INFO VANICO-MARONYX

ISSUE 123

JUNE 2009

Corrections to be made Eclipse Price list, page 12

- Top illustration:

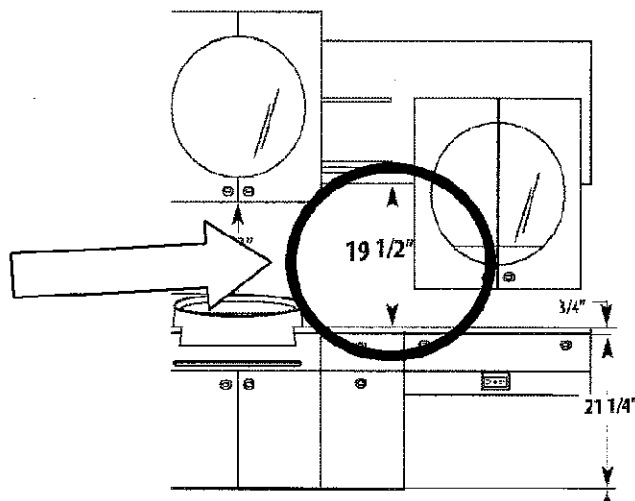
Replace the measurement 17" by 19 1/2" (height between the countertop and the decorative wall panel).

- "Electrical & Plumbing" illustration:

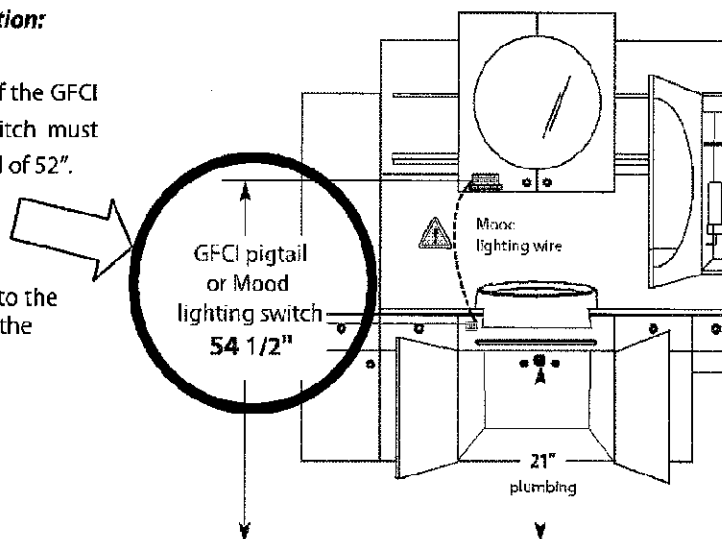
VERY IMPORTANT: The height of the GFCI pigtail or the mood lighting switch must be at 54 1/2" from the floor instead of 52".
